## PIONEER HUMAN SERVICES PIONEER BELMONT

SDCI PROJECT #3028324

ADMINISTRATIVE PACKET

SUBMITTED DATE: 08/06/2018

1e. SETBACKS AND FOOTPRINT COMPARISON

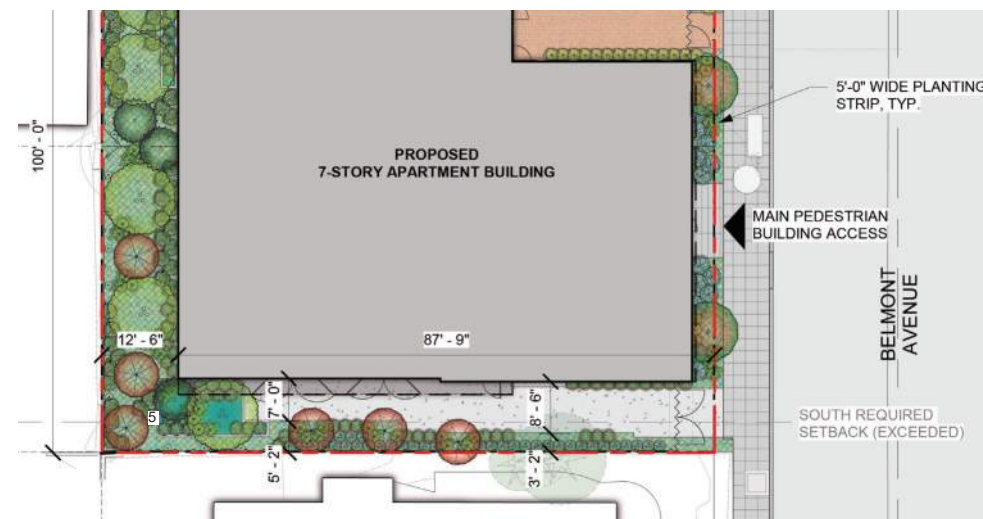
d. The Board did not support the ground level setback and overhanging upper level along the street edge as the "floating mass" fails to respond to the immediate architectural context and contributes to a more institutional or commercial character, rather than residential. The Board directed the applicant to eliminate the ground level setback, while acknowledging SDOT's comments regarding providing space to accommodate street trees – see Item #4, Landscaping, below. (CS3-A-1, DC2, DC2-C-3)

e. The Board indicated they would be open to a departure from the required rear setback if the departure contributes to the resolution of guidance regarding the ground level setback and provision of street trees. The Board noted that street trees should not be located beneath an upper level overhang. (CS3-A-1, DC2, DC4-D-1, DC4-D-3)

Response: The ground level setbacks and overhang on the street (east) side have been eliminated per the Board's direction. The upper levels were shifted back to align with the ground level allowing for planting and street trees.

Response: Resolution of the design after elimination of the ground level setbacks as suggested by the Board (item 1.d) results in the need for a departure from the rear setback by 2'-6". In addition, these design changes create more space for the street trees, which will no longer be located under an overhang.

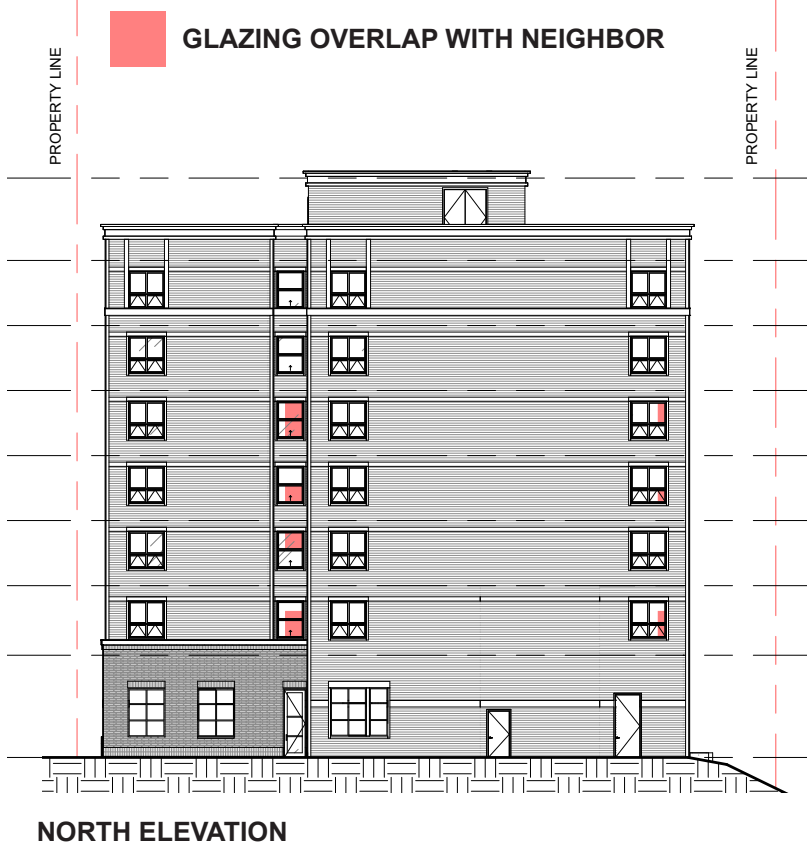
c. The Board noted that materials should be thoughtfully composed with intentionally designed reveals. Material reveals should be well documented at the Recommendation phase. (DC2-B-1, DC4-A-1)

Response: Masonry detailing has been explored to create interest at the pedestrian level using banding relating to the adjacent masonry buildings, projected elements and accent colors. Fiber cement lap siding will add shadow lines mimicking the scale of the masonry with trim elements which highlight the recessed windows and accentuate the top and cornice of the building.

COURTYARD RENDER FROM SIDEWALK

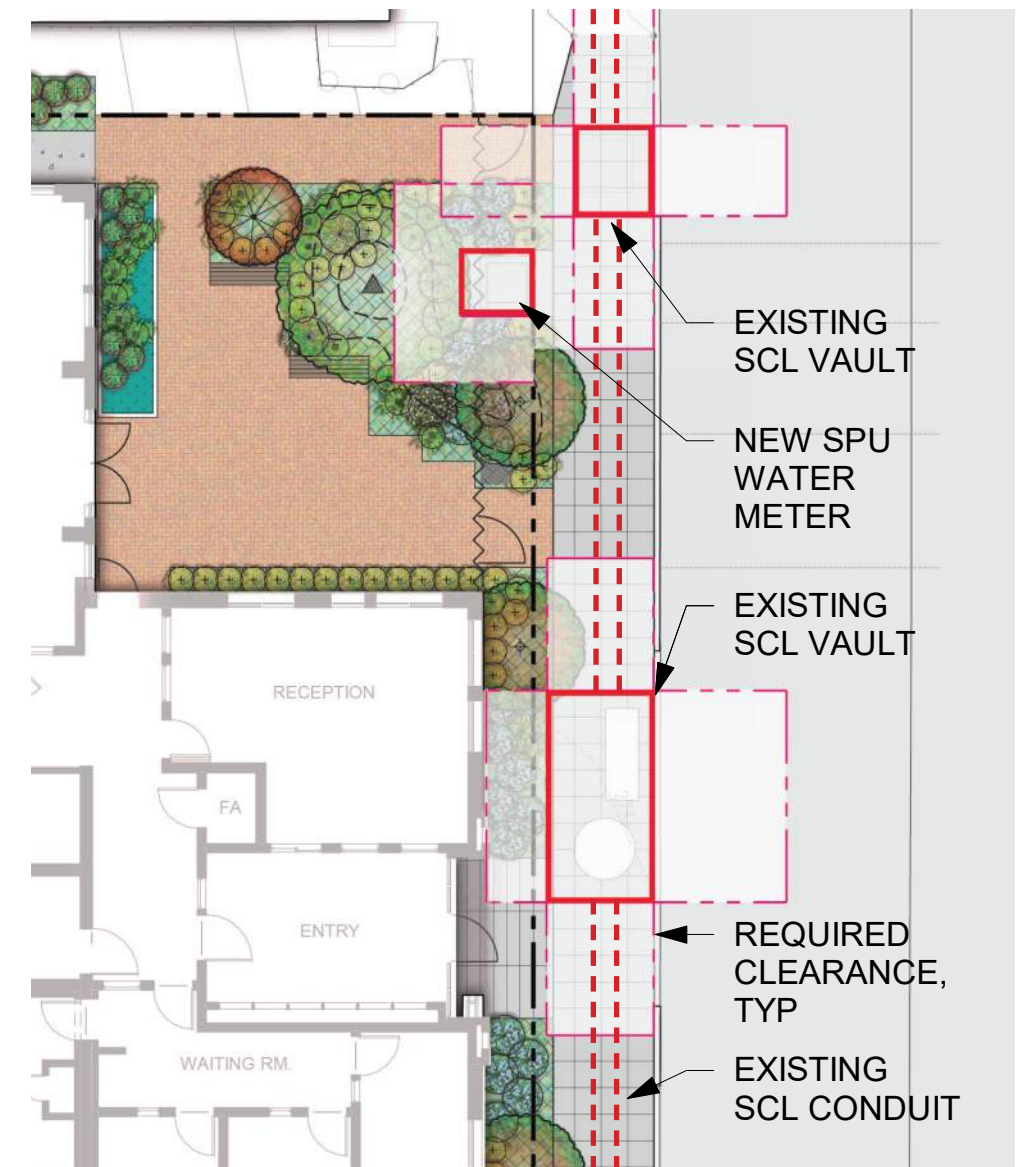
a. The Board heard public comment, but ultimately supported the proposed siting of the courtyard in the northeast corner provided that it is perceived as a lush green space from the public realm; a true respite, not just a gap in the street wall. (PL1-A, DC2-A-1, DC3-B, DC4-D)

b. In response to public comment, the Board noted that lighting and fencing should create a safe and secure courtyard while contributing to the appearance of an attractive street edge and inviting space. (PL2-B, DC3-C-2, DC4-C, DC4-D)

c. The Board requested more information on the design of the courtyard and its relationship to adjacent interior uses. Particularly, how the courtyard will be secured and programmed, as well as activated by adjacent uses. (PL1-A, DC1-A-2, DC1-A-4, DC3-A-1, DC3-B)

Response: The design team has noted the public comments and the Board's recommendation and has made revisions for a greener, lush courtyard with additional planting and berms.

Response: The design team has noted the public comments and the Board's recommendation regarding courtyard security. The courtyard will be well lit and easily visible from the Community Room and Reception desk. Building staff will monitor all common spaces in the building around the clock, including the courtyard. The courtyard design also includes perimeter fencing to control site access and landscaping that shields the street.

Response: The courtyard can be accessed from within the building from two active spaces: the main circulation corridor and the Community Room.

Fencing to control site access, as well as exterior lighting and a visual connection with the 24-hour building staff will ensure the courtyard security.
